# 1957 - 1958 Corvette: Service News: Corvette 4-Speed Transmission - Harsh Shift Into Third Speed

**Source:** Chevrolet Service News

**Date:** December, 1957

**Subject:** Corvette 4-Speed Transmission - Harsh Shift Into Third Speed

*Fig. 3--Checking Third Speed Gear*

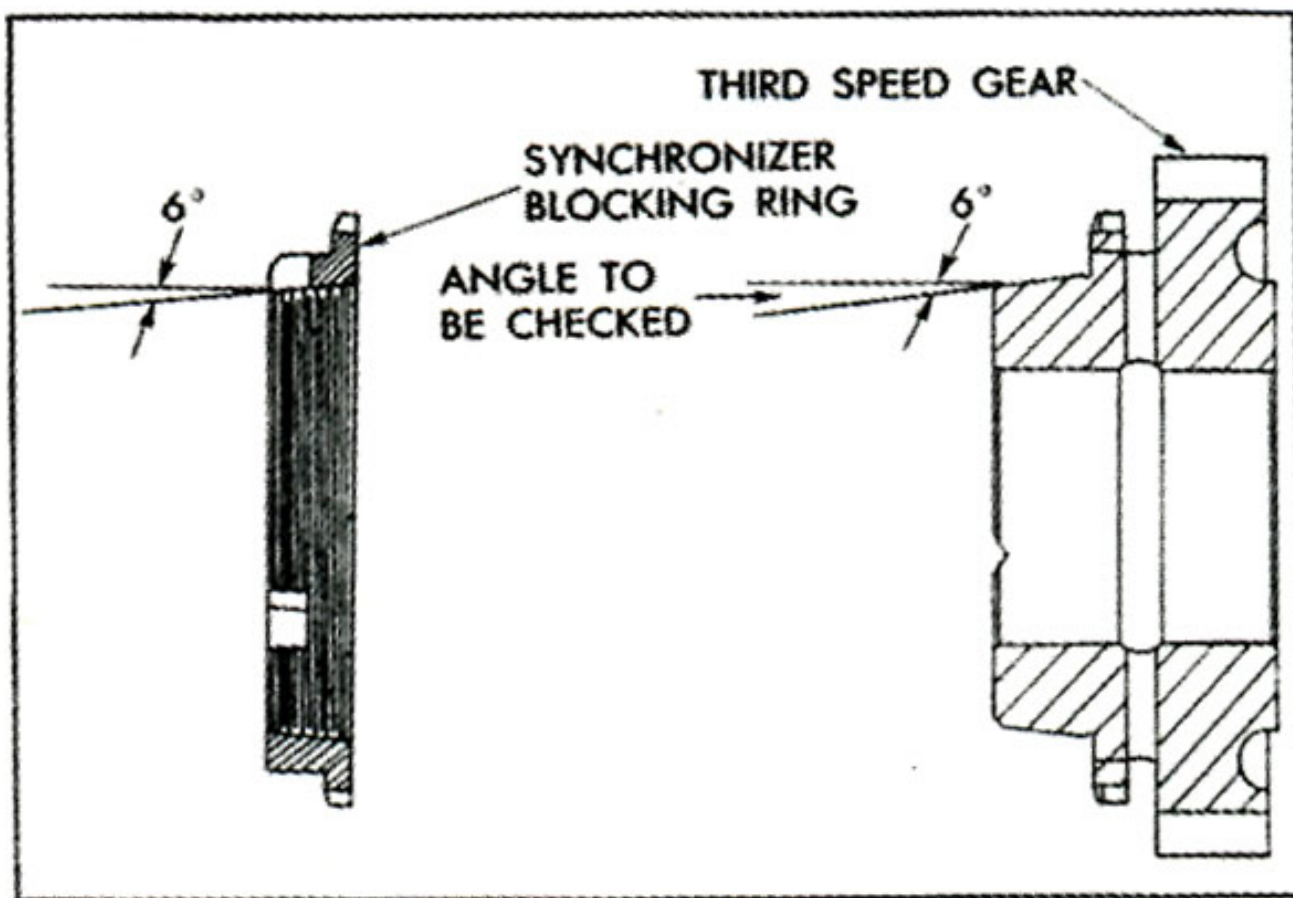
Some 1957 and 1958 Corvette four-speed transmissions have been built incorporating a third speed gear with  $7^\circ$  cone angle rather than the specified  $6^\circ$ , as illustrated in Figure 3. This may cause a harsh shift into third speed due to the resultant improper engagement of the synchronizer blocking ring and third speed gear cone.

The suggested correction, if the harsh shift is encountered, is to replace the third speed gear assembly No. 3743452 and the synchronizer blocking ring No. 3709348.

1. Coat I.D. of blocking ring lightly with a dye such as Prussian Blue.
2. Carefully install the blocking ring on the third gear cone to obtain an engagement impression.
3. If the Prussian Blue impression on the cone is all at the rear (or predominantly at the rear) the cone angle can be assumed to be  $7^{\circ}$  and should not be used. If the Prussian Blue is more or less evenly distributed on the cone surface, the angle is correct.
